## MONITORING YEAR 3

### MOORES FORK STREAM MITIGATION PROJECT

Wildlands Engineering, Inc. (Wildlands) has reviewed the Division of Mitigation Services (DMS) comments from the Draft Monitoring Year 3 report for the Moores Fork Stream Mitigation Project. The following Wildlands responses to DMS's report comments are noted in italics lettering.

Figure 3.4 Integrated Current Condition Plan View (Sheet 4 of 6)  
Moores Fork Stream Mitigation Project  
DMS Project No. 94709  
Monitoring Year 3 - 2018  
Surry County, NC

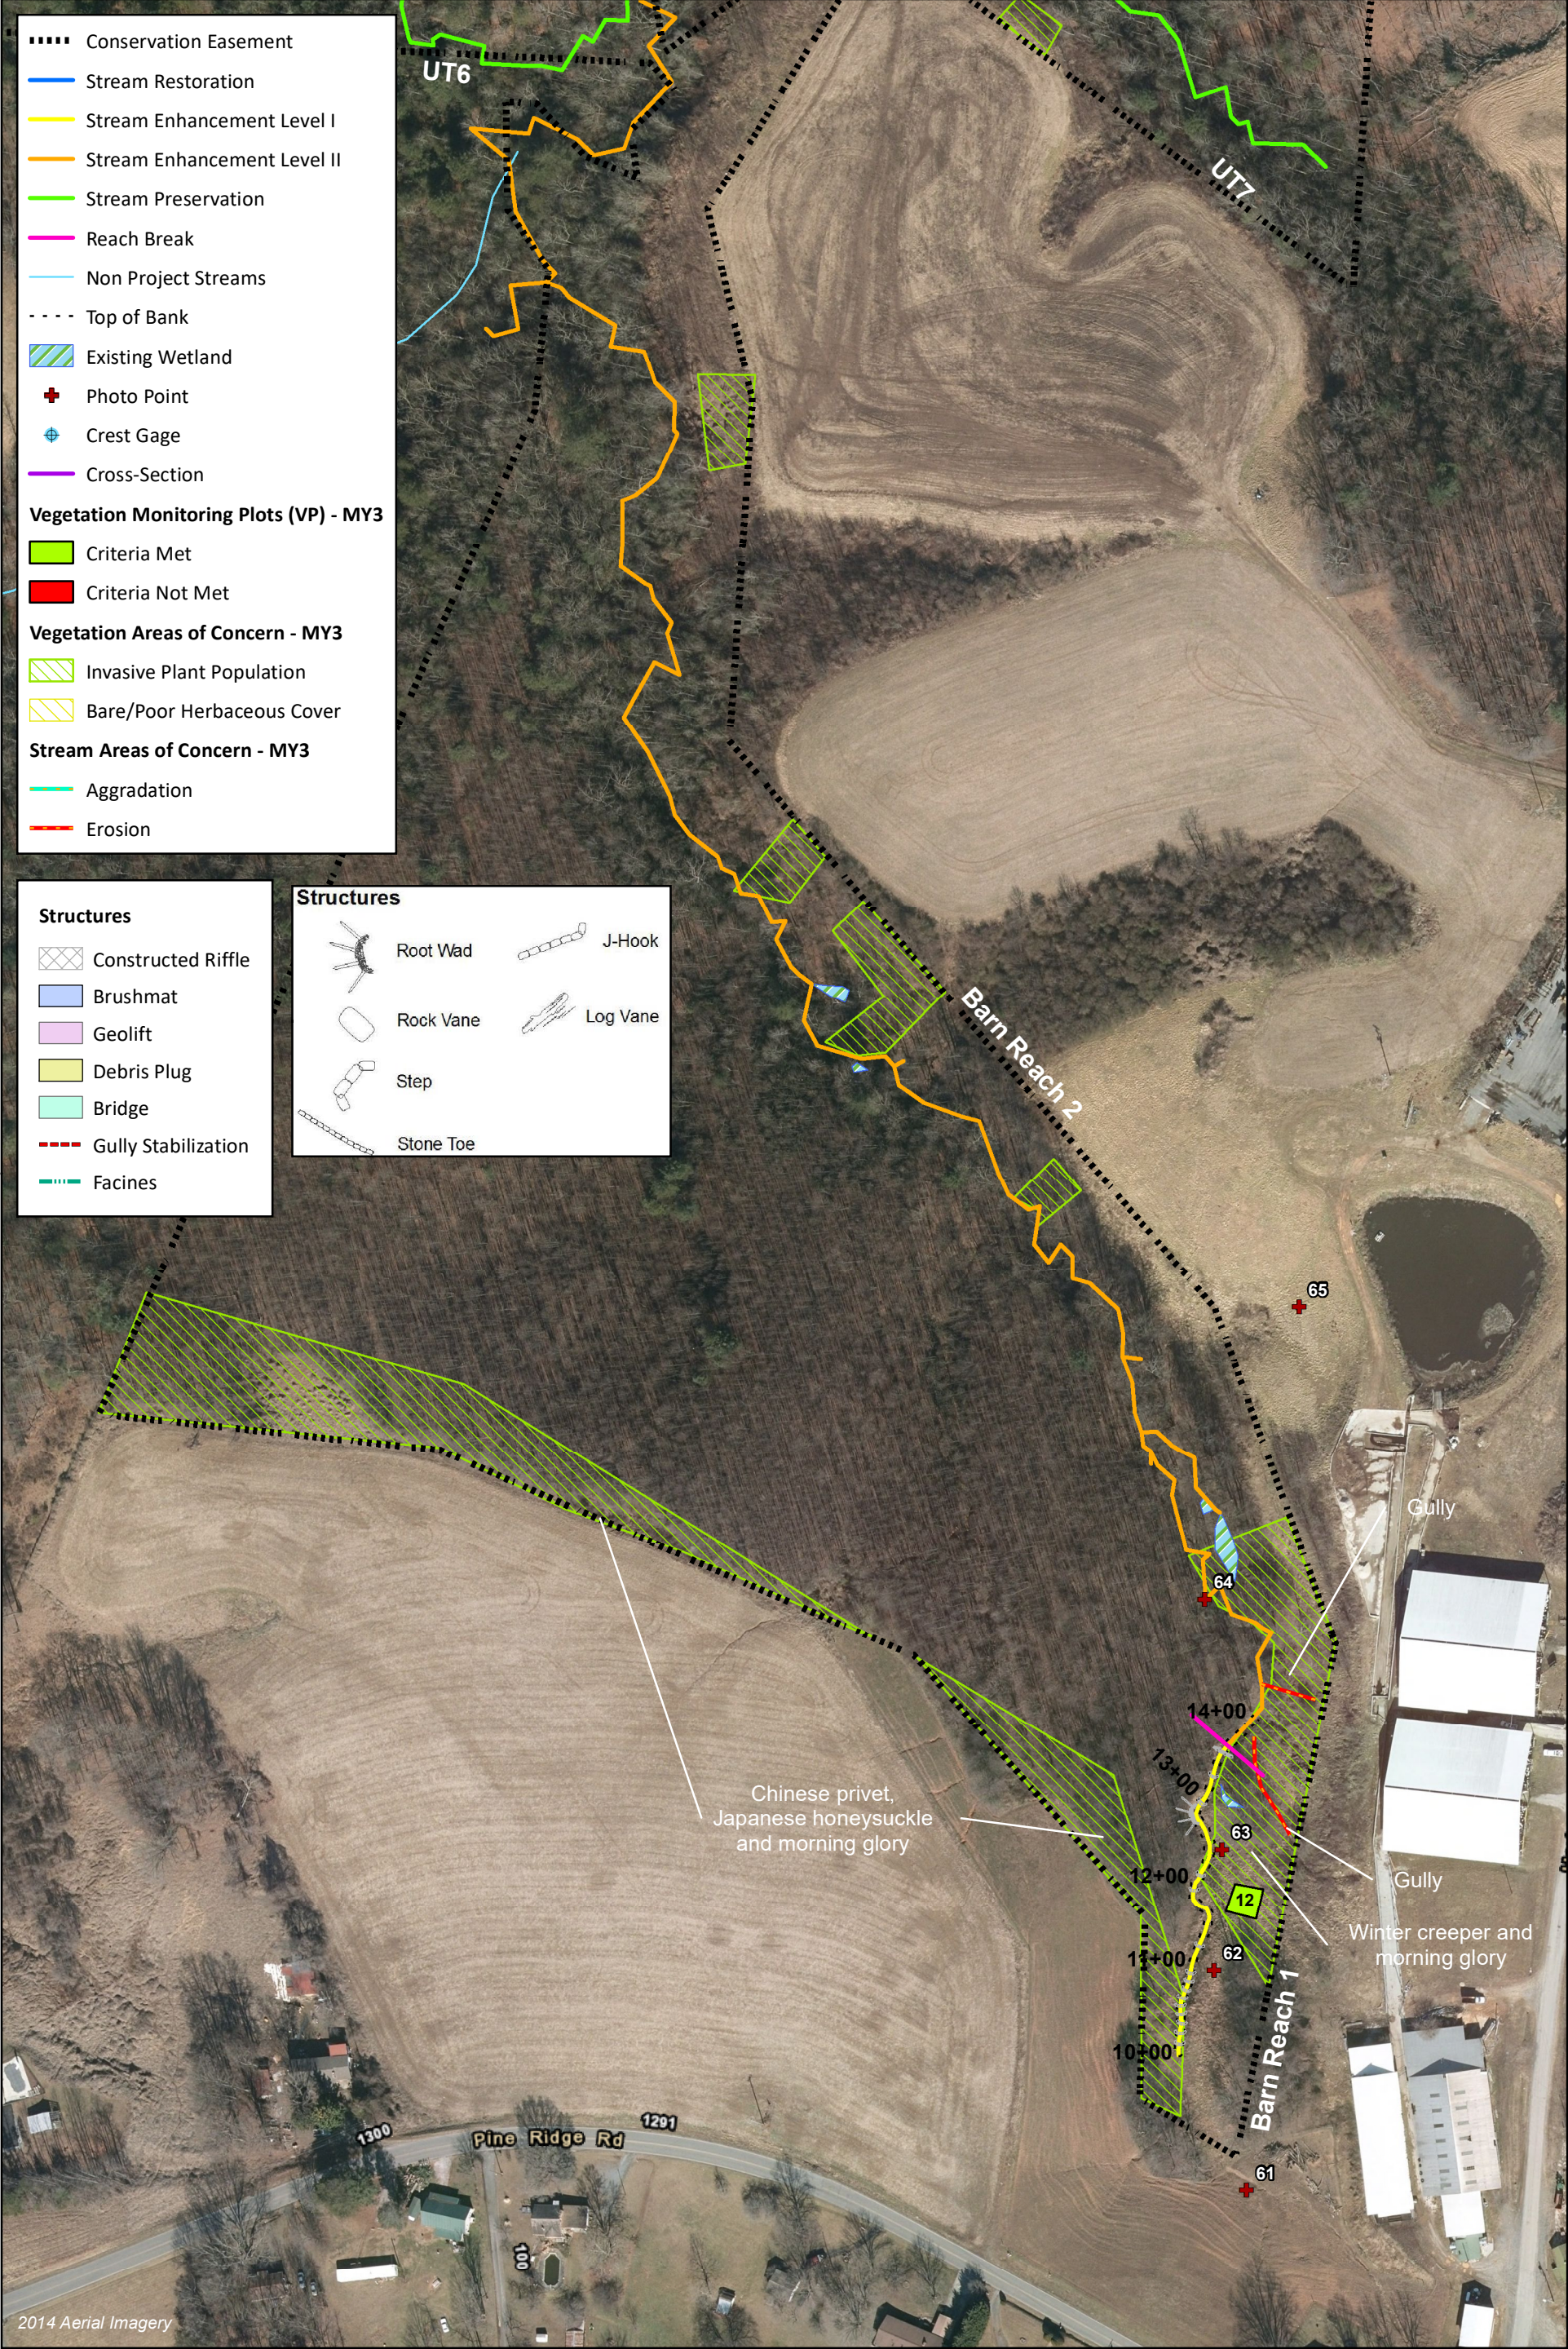
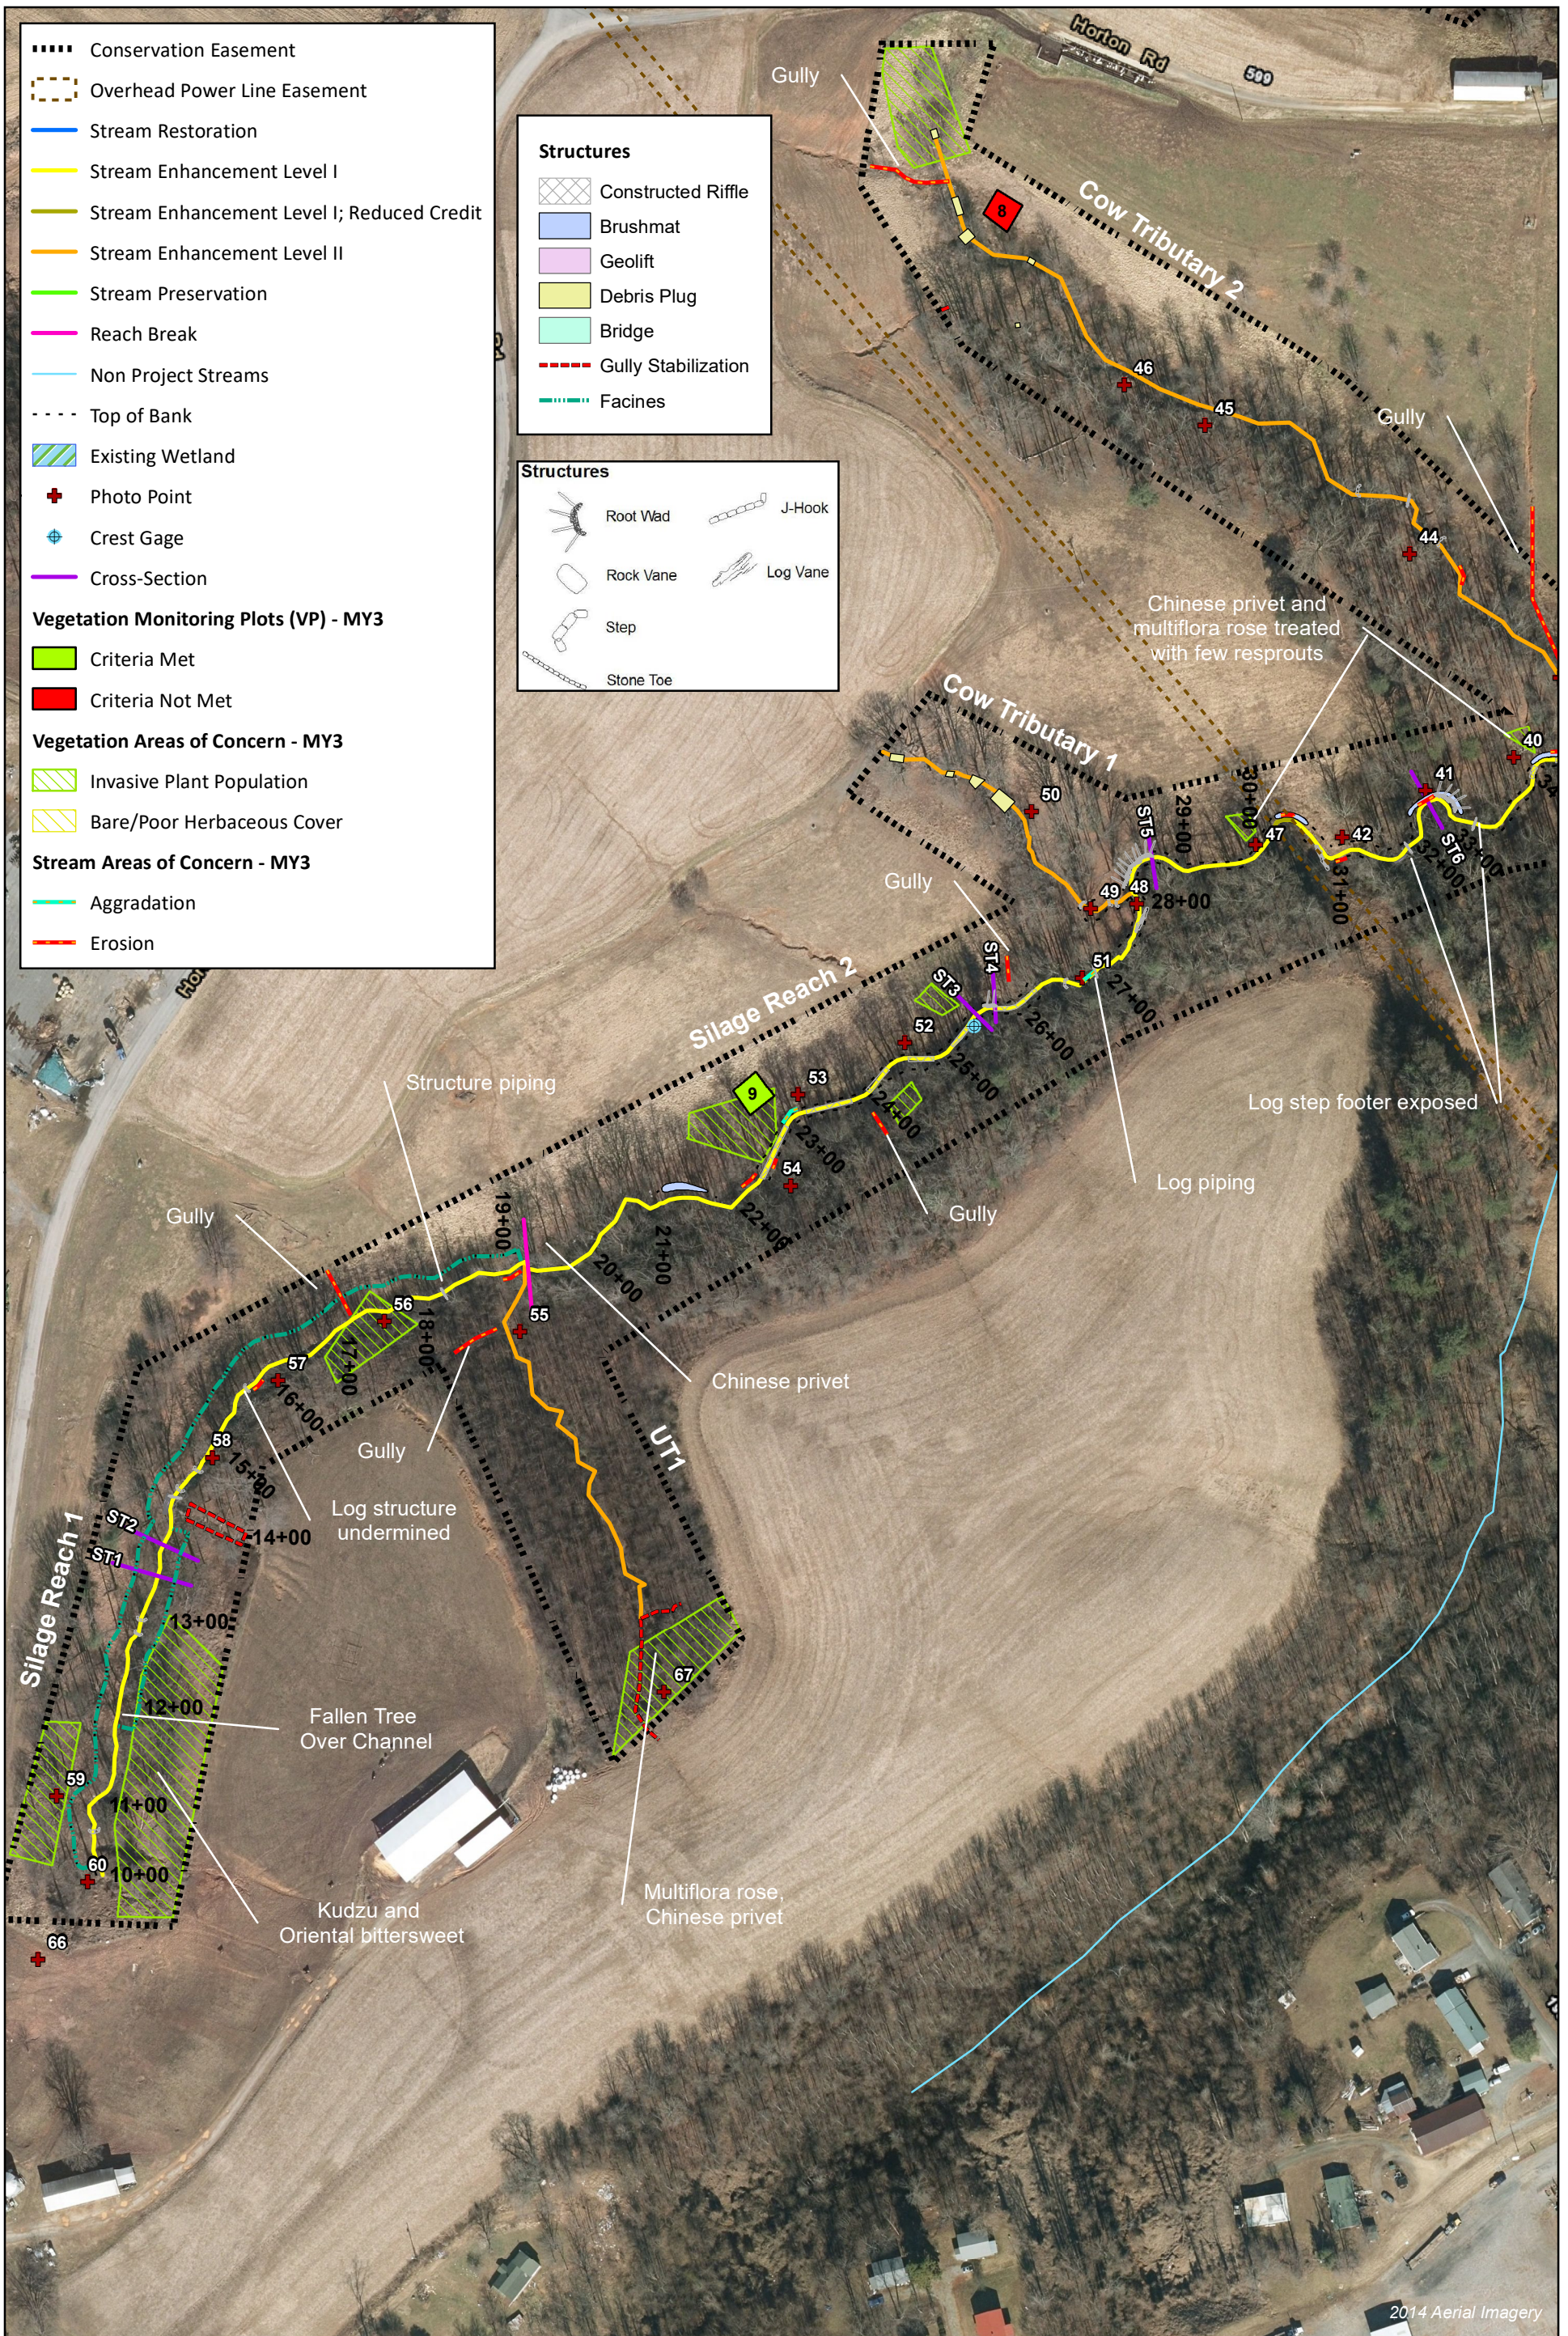
**DMS comment; CCPV: Thanks for providing updated invasive species polygons. Please continue to update as treatment occurs and populations are reduced. This map is a useful tool for the contractor treating the site.**

**DMS comment; CCPV: Please update map with the two additional utility lines.**

**DMS comment; DMS made a site visit on November 26, 2018. We are exploring the possibility of remedial action to some areas depicted on the CCPV as being problem areas. DMS will coordinate with Wildlands when final decisions have been made.**

*Wildlands response; Wildlands will continue to update the CCPV figures as treatment of invasive species occurs and populations are reduced.*

*Wildlands response; The CCPV figures have been updated with the additional utility lines crossing on Moores Fork and Corn Trib.*

*Wildlands response; Thank you for this information. Wildlands will look for communication from DMS about possible remedial action to some areas of concern depicted on the CCPV.*
